Access Compliance Report Public Rights-of-Way (Curb Ramps)

Main Street: MESSERSMITH_AVE Cross Street: GREENWICH_LN Location: SE

ADA ID: RPAT211118095238 Ramp Type: Type 1 - Perpendicular Diagonal Initial Pass/Fail: Pass Overall Compliance: No Severity Score: 20

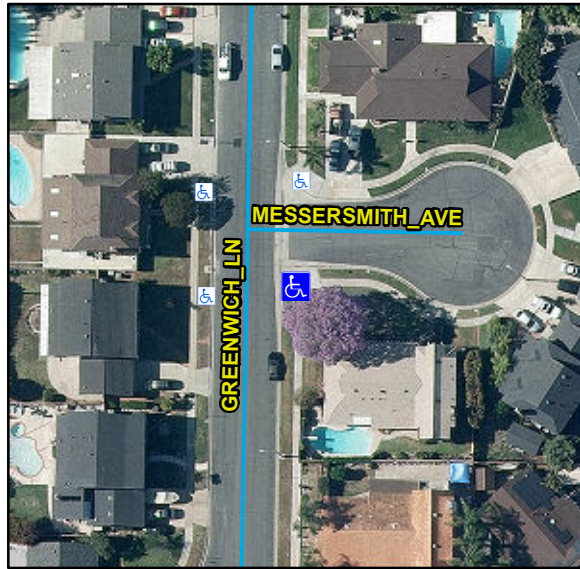
Compliance	Description	Data	Compliance	Description	Data
N/A	Ramp Length (in)	116	N/A	Flare Type LT	
Yes	Ramp Width (in)	50			Sloped
Yes	Ramp Run Slope (%)	6.6	N/A	Flare Slope LT (%)	4.4
Yes	Ramp Cross Slope (%)	0.3	N/A	Flare Traversable LT	No
N/A	Landing Present	No	N/A	Flare Type RT	
N/A	Landing Length (in)	N/A			Sloped
No	Landing Width (in)	N/A	N/A	Flare Slope RT (%)	3.6
No	Landing Run Slope (%)	N/A	N/A	Flare Traversable RT	No
No	Landing Cross Slope (%)	N/A	No	DWS Provided	No
N/A	Landing Movement Obstructed?	No	N/A	DWS Contrast	N/A
	Landing Movement Type	N/A	N/A	DWS Length (in)	N/A
N/A	Landing Shared	N/A	N/A	DWS Full Width	N/A
N/A	Clear Space	Yes	N/A	DWS Offset Left (in)	N/A
N/A	Clear Space To Crosswalk (in)	48	N/A	DWS Offset Right (in)	N/A
N/A	Marked Crosswalk 1	No	N/A	Marked Crosswalk 2	No
	Crossing 1 Direction	N		Crossing 2 Direction	W
	Marked Crosswalk 1 Width (in)	N/A		Marked Crosswalk 2 Width (in)	N/A

N/A	Ramp Inside Crosswalk 1	N/A	Yes	Ramp Inside Crosswalk 2	N/A
	Crossing 1 Slope (%)	2.5		Crossing 2 Slope (%)	5.1
	Crossing 1 Cross Slope (%)	1.4		Crossing 2 Cross Slope (%)	0.9
Yes	Gutter Ponding	No	No	Curb Slope	13.1
Yes	Gutter Lip Height (in)	0		Road Run Slope (%)	0.4
Yes	Gutter Run Slope (%)	0		Road Cross Slope (%)	1.9
Yes	Gutter Cross Slope (%)	0.6			
Yes	Overall Surface Condition: Acceptable		No	Perp Joint Present	No
	Cross Gutter Present?	Yes		Spandrel Present?	Yes
	Replace Cross Gutter?	No		Replace Spandrel?	No

Remove & Replace Curb Ramp With Two New Directional Ramps or Equivalent.
